FREDERICK COUNTY PLANNING COMMISSION

TITLE: Linton at Ballenger Section IV Combined Preliminary Subdivision/Site Development Plan

FILE NUMBER: S-1128 (SP-05-08) AP 14782, APFO 2121, FRO 14784

REQUEST: Combined Preliminary Subdivision/Site Development Plan Approval

Exhibit 1- Site Plan Rendering
Exhibit 2- Modification Statements

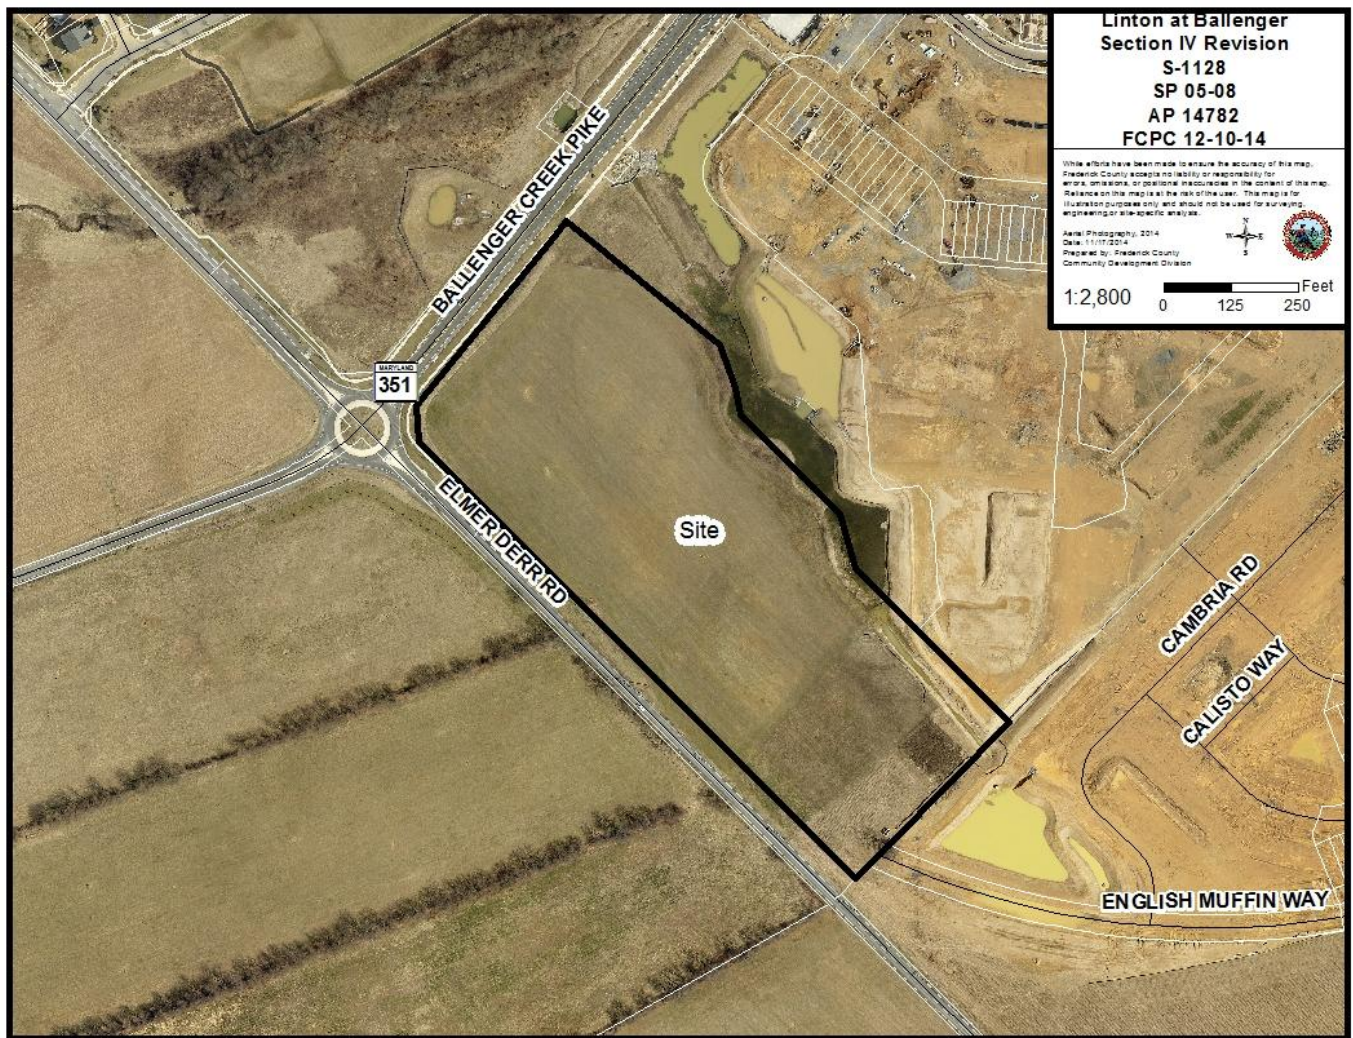
The primary issue associated with this project was the overall design and redesign of Section IV. Staff worked closely with the Applicant in order to accommodate the parameters of the redesign, while avoiding the placement of the backs of homes along Ballenger Creek Pike, retaining open space, and providing increased connectivity. This current proposal has more east-west alley and lane connections, which helps overall connectivity as well as producing a ring road around Section IV.

The Applicant has provided a BRL modification table on Sheet 1 of 13 of the Combined Preliminary/Site Plan, as well as a setback graphic shown on Sheet 3 of 13. The requested setback modifications will allow for a superior layout of lots, providing a more compact neighborhood which will have a strong pedestrian orientation, greater vehicular connectivity and redundancy, while providing a better overall network of open space areas. The modification request is consistent with the provisions of the PUD district regulations. Staff has no objection to the proposed building setbacks and height as listed on Sheet 1 of 13 of the Combined Preliminary/Site Plan.
